SUBJECT: SEP TOPICS III-6, SEISMIC DESIGN CONSIDERATIONS  
AND III-11, COMPONENT INTEGRITY - HADDAM NECK PLANT

HADDAM NECK PLANT

FIGURE 1. COMPARISON OF HADDAM NECK SPECTRUM USED FOR ANALYSIS WITH LLNL SITE SPECIFIC SPECTRUM

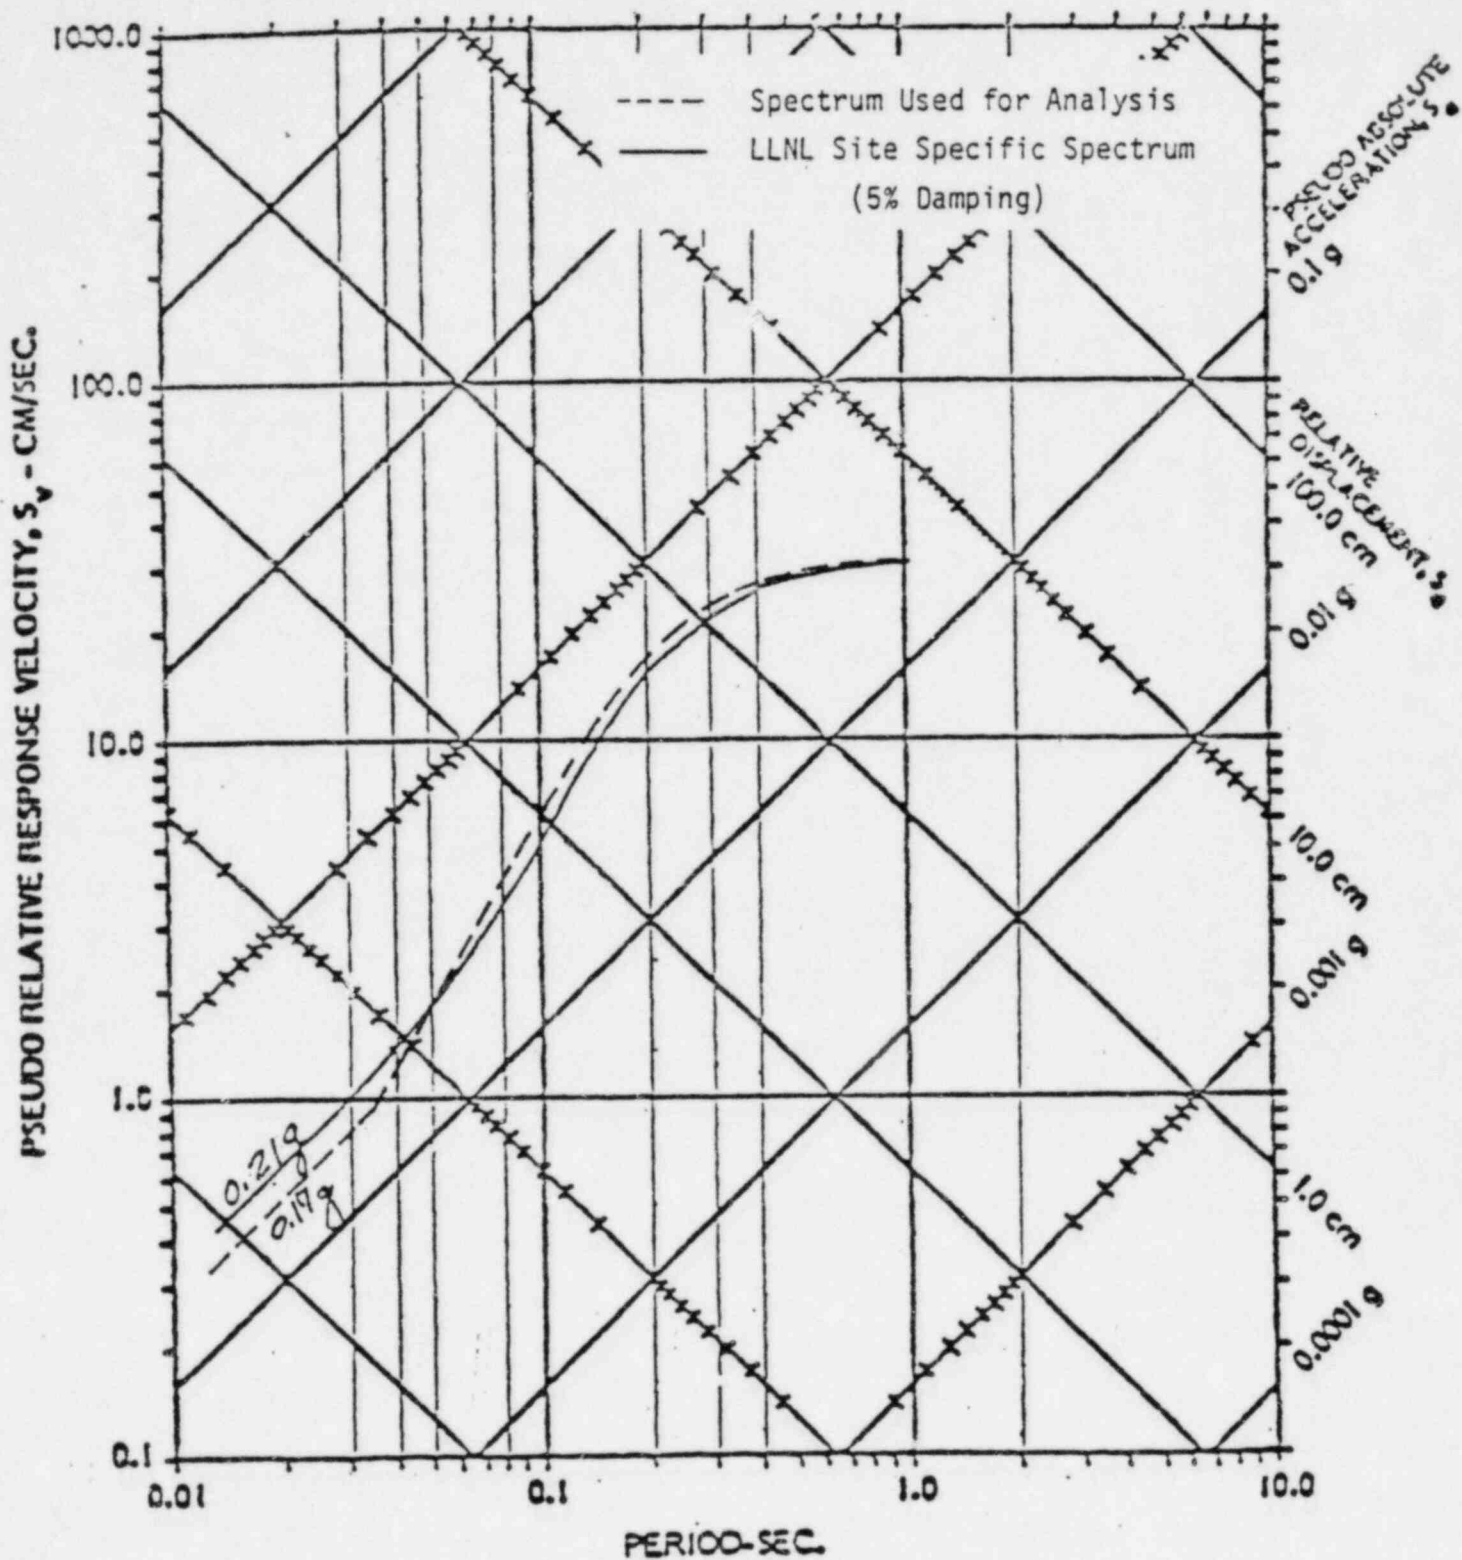
encouraged the licensee to propose its own site specific ground response spectra before the final decision about seismic input of this site was made. In Figure 1, a comparison was made for the spectrum recommended by the staff and the spectrum proposed by the licensee (Ref. 6). According to the staff's review, the site specific ground response spectra proposed by the licensee are considered as an appropriate input for the seismic reevaluation of the plant facility.

The seismic input used in the analysis was defined by response spectra anchored to 0.17g peak ground acceleration rather than the 0.21g site specific spectra developed by LLNL for the Connecticut Yankee site. The spectra used for analysis exceed the LLNL site specific spectra at all frequencies less than approximately 20 Hz. A comparison of the 5% damped ground response spectrum used for the analysis with the 5% damped LLNL site specific response spectrum is shown in Figure 1. Most of the response of the primary structures results from excitation in the frequency range less than 20 Hz so the response of these structures is expected to be conservatively predicted using the spectra used in the analysis rather than the LLNL site specific spectra. However, the effects of the reduced acceleration levels should be considered for rigid equipment located near the base slabs of the Haddam Neck structures.
